# JCTVC-H0463: Comments on specifying tile support in HEVC Profiles and Levels

**Wade Wan and Tim Hellman**

Broadcom Corporation

# Constraining the maximum number of tile columns

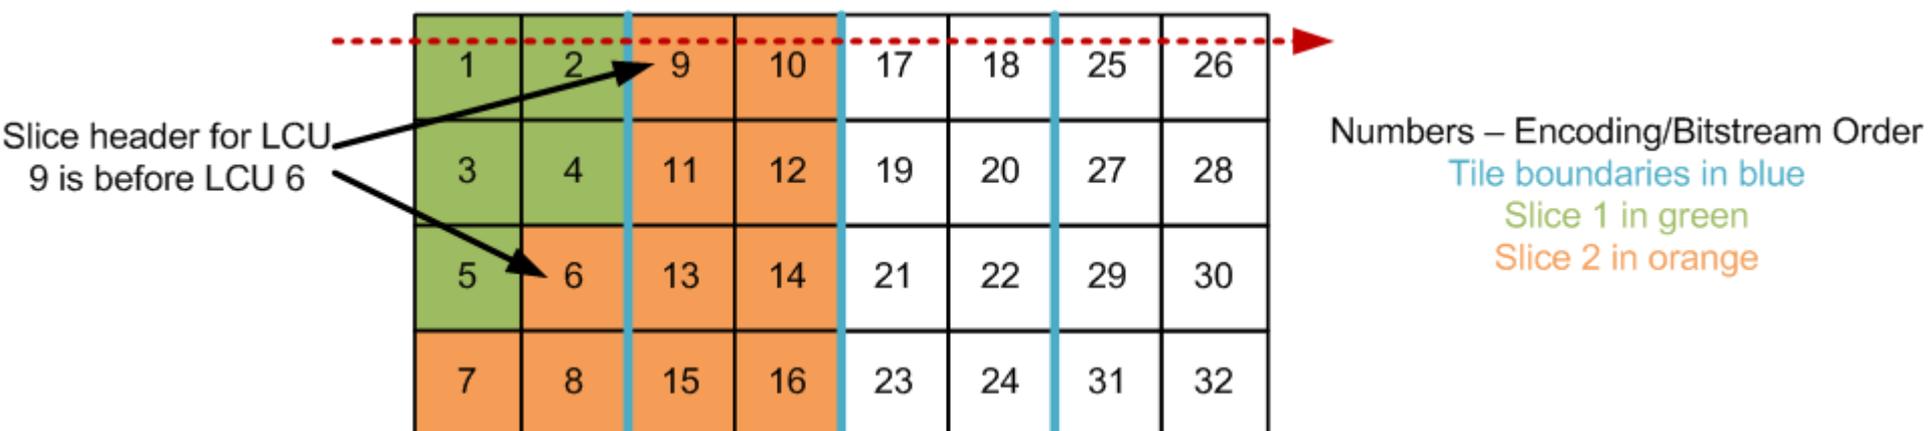
Blue arrows represent bitstream jumps to handle tile transitions to process one LCU row when processing a stream with tiles in LCU raster scan order

- Save/reload at every vertical boundary (but does not exist for independent tiles)
  - As an aside, similar (but not as prominent) issues for wavefronts
    - Bitstream jumping does not exist if substream interleaving is not used
    - Wavefront schemes do not involve more than one save/reload per LCU row
- **Constrain the maximum number of tile columns to two**
